Haddam Neck Plant
Additional Information in Support of Proposed Changes
 to Technical Specifications

HADDAM NECK PLANT
ADDITIONAL INFORMATION IN SUPPORT OF PROPOSED CHANGES
TO TECHNICAL SPECIFICATIONS

QUESTIONS TELECOPIED FROM NRC AS "ENCLOSURE 1",
HADDAM NECK, CASK HANDLING OPERATIONS, REQUEST FOR ADDITIONAL INFORMATION

FIGURE 1

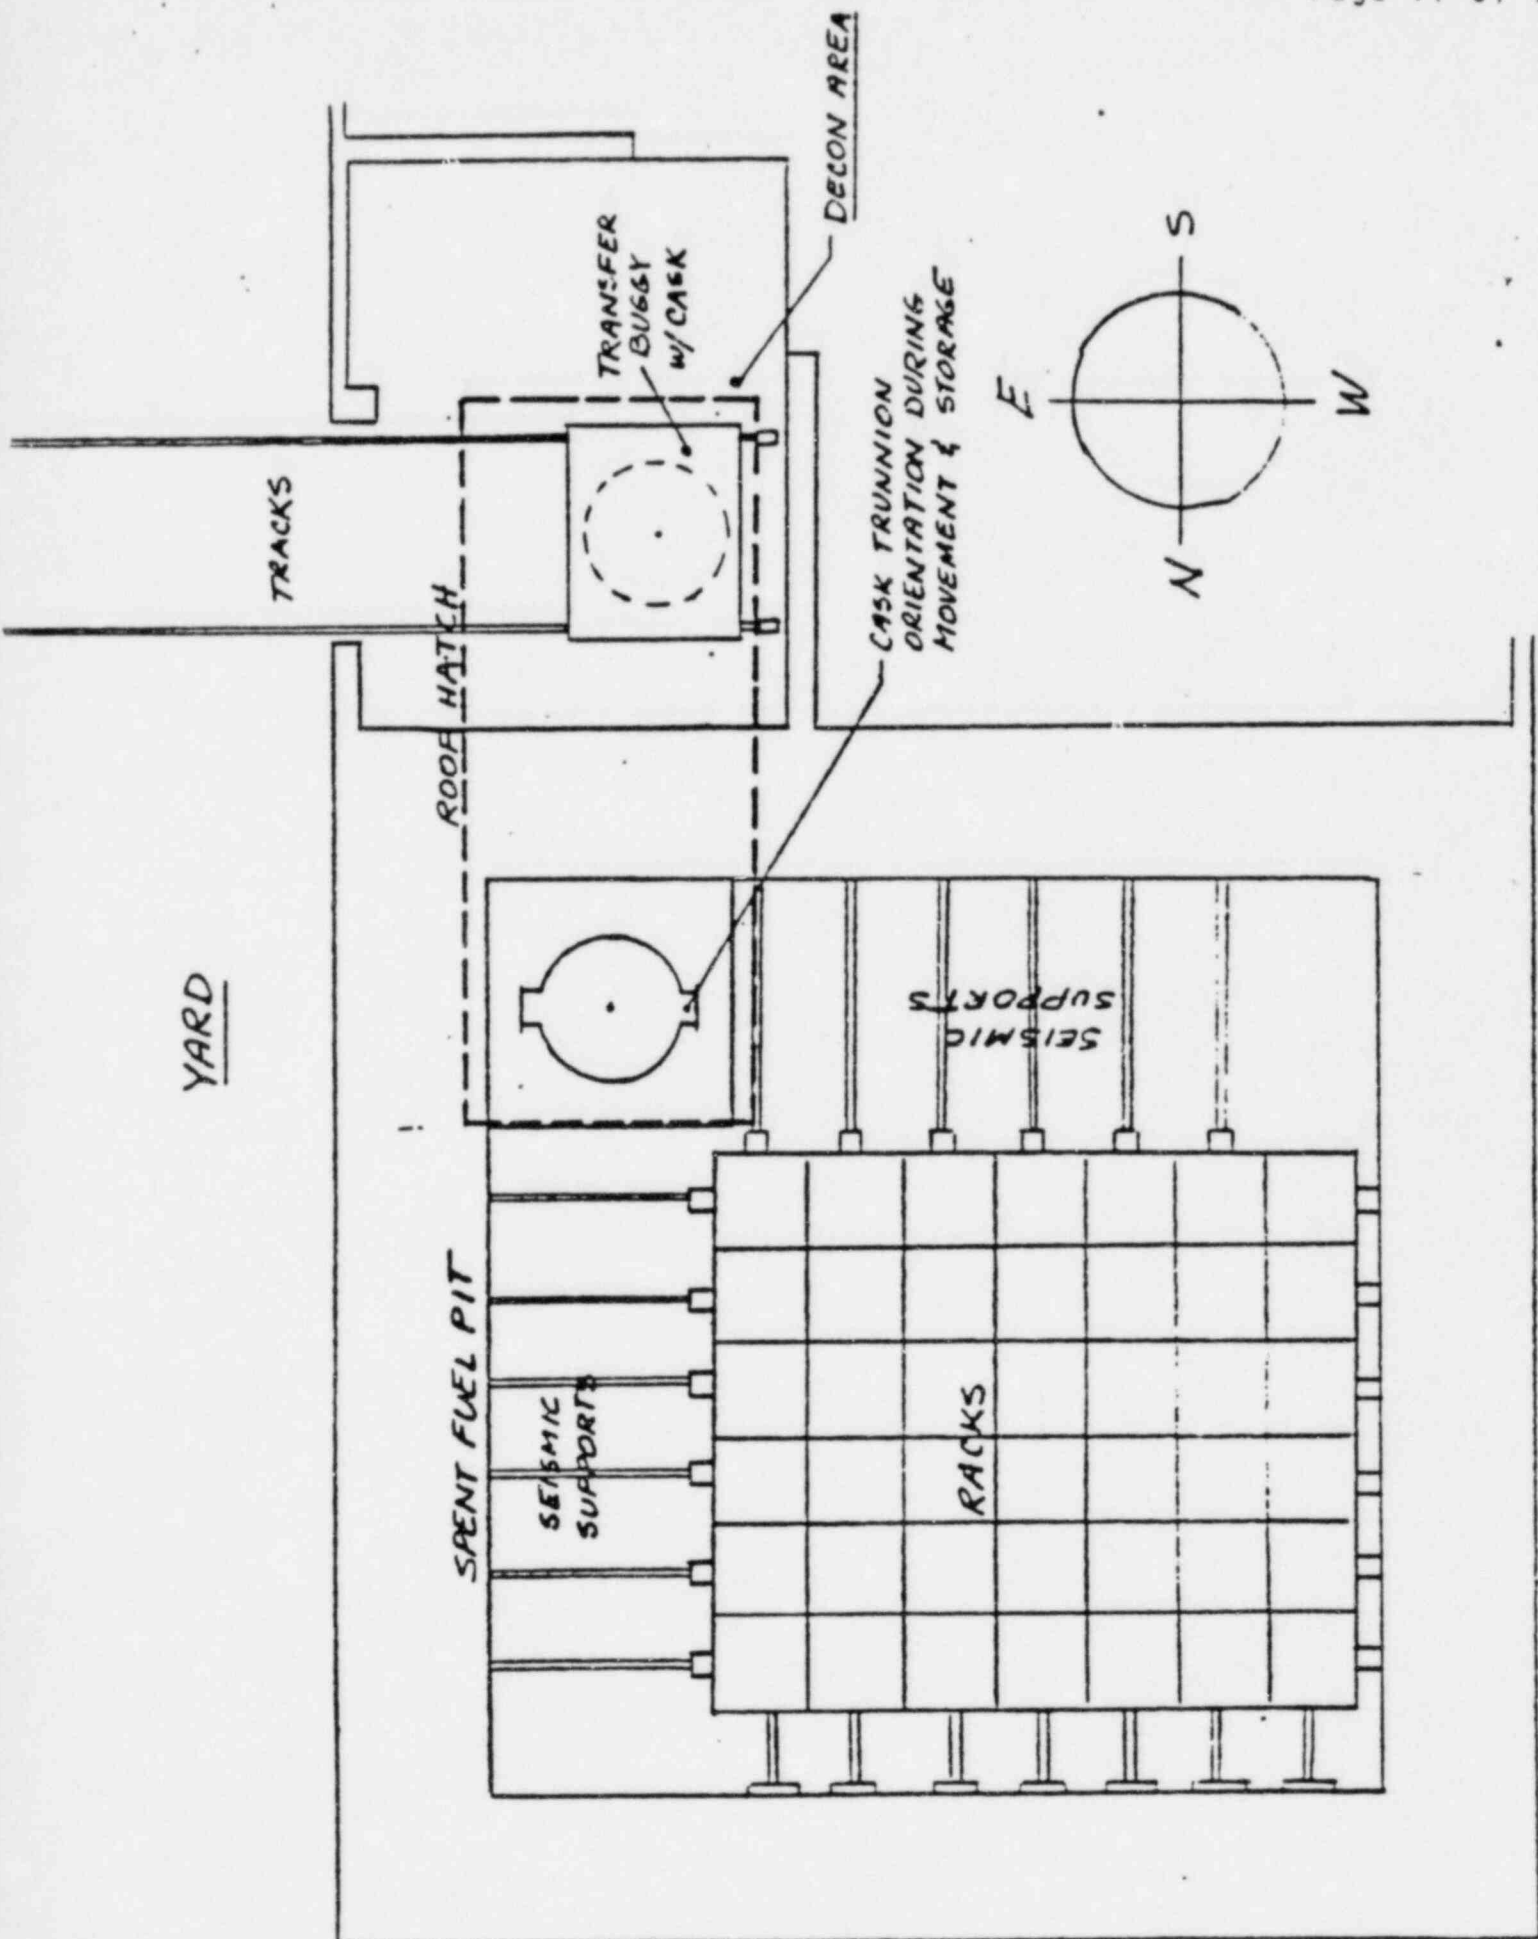
Verify that procedures are developed and followed for the proper handling of the spent fuel cask and related heavy loads (such as the hatch cover), and that these procedures include: identification of proper equipment and components for performing these operations; required inspections before movement of the load and related acceptance criteria; the steps and proper sequence to be followed in handling the load; definition of the safe load path; and special precautions.

Procedures for cask handling operations were supplied by NAC. These have been incorporated into the site-specific procedures for the Haddam Neck Plant. The path of the cask is indicated on Figures 1 and 2 of this Attachment. The cask cover will be stored in a position, suspended off the fuel crane bridge, which will be above the seismic supports, not above the fuel.

The yoke will be oriented (by procedure control) in the East-West direction within the Spent Fuel Building. Thus, if one end of the yoke should break, when the cask is over the pool, the cask would tip either in the East direction away from the fuel storage pool, or in the West direction, over the fuel rack seismic restraints, thus, providing additional protection against the possibility of the cask tipping towards the stored fuel assemblies.

FIGURE 2

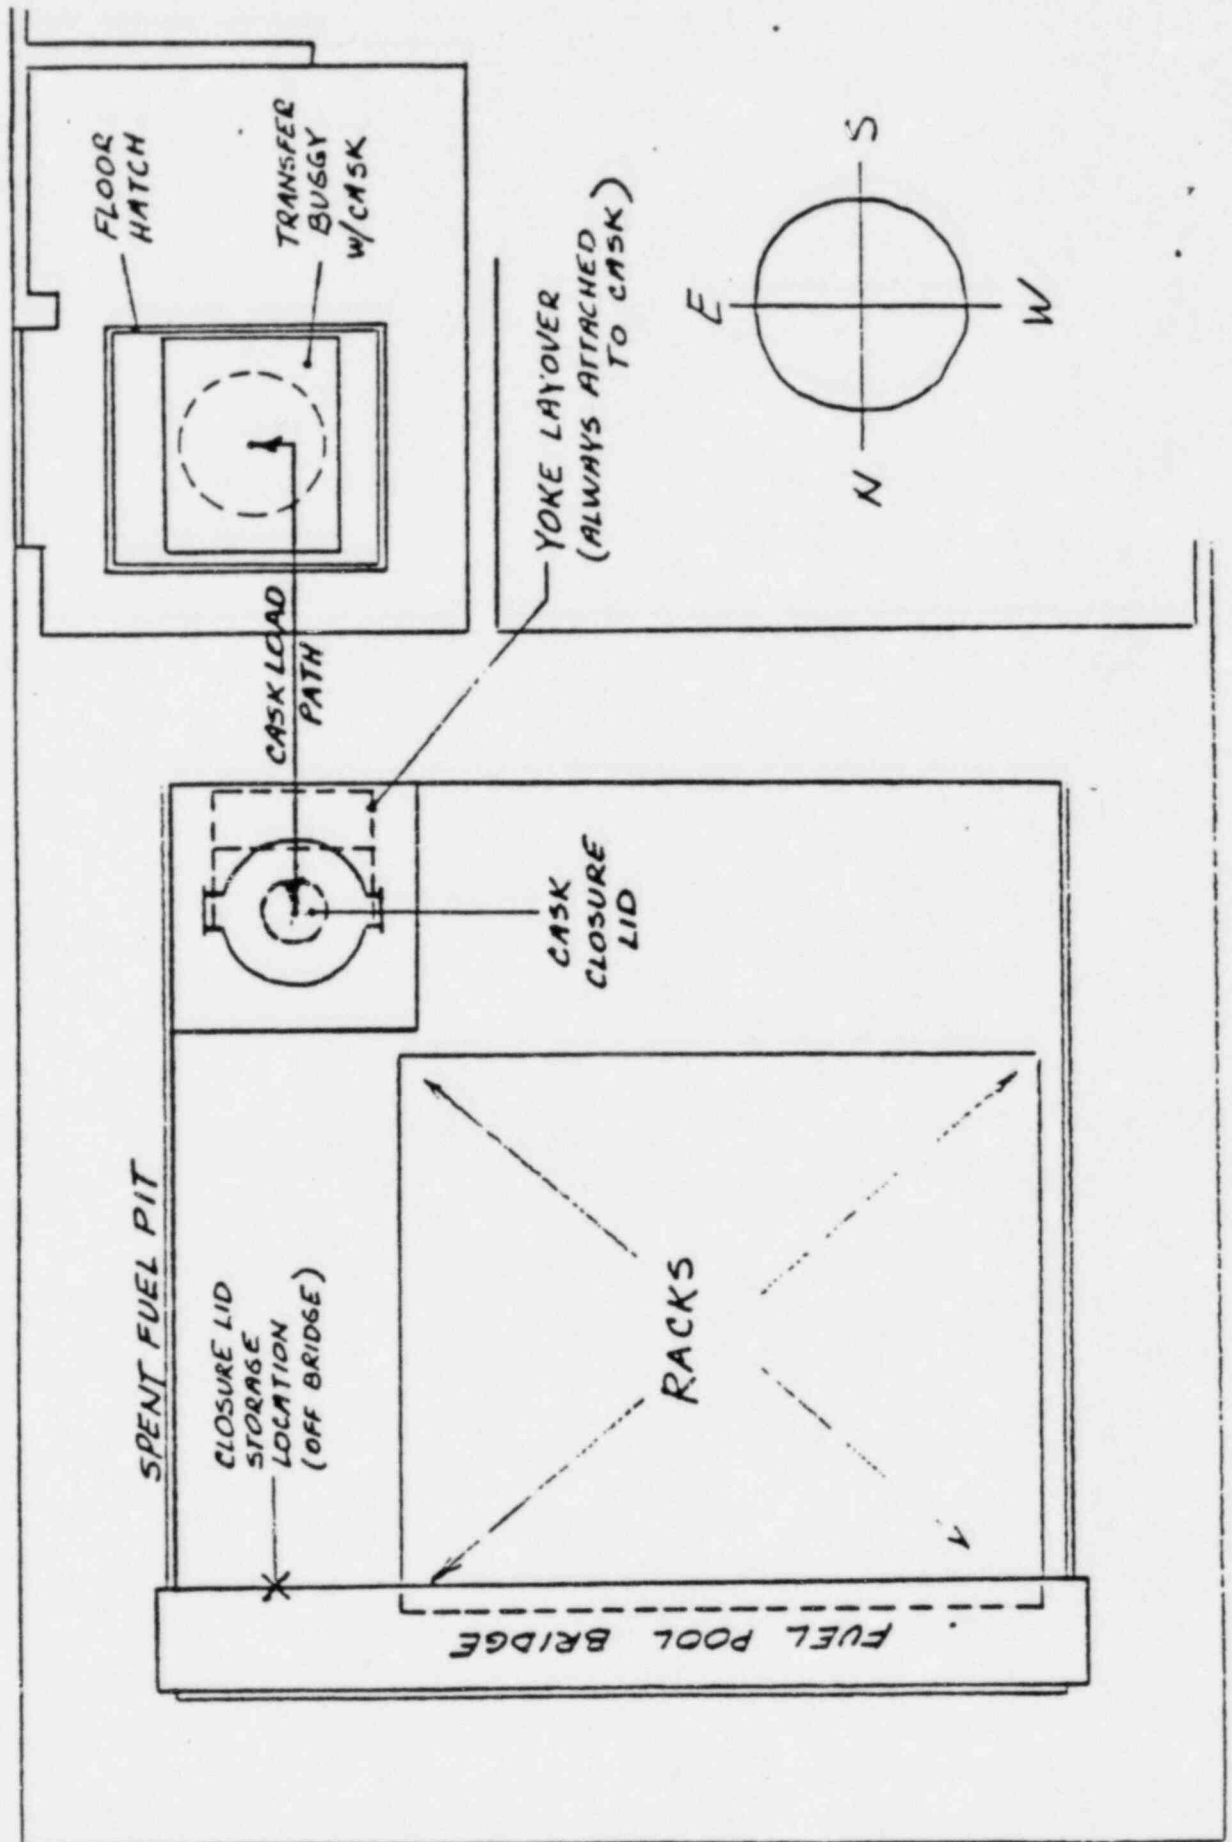
- a) Identify the weight of the spent fuel cask cover.
- b) Identify the crane used for handling this cover, and the defined safe load path for its movement.

The spent fuel cask cover weighs 750 pounds. It is removed from the cask using the Refuel Building's 3-1/2 ton crane. The defined path is indicated on Figure 2.
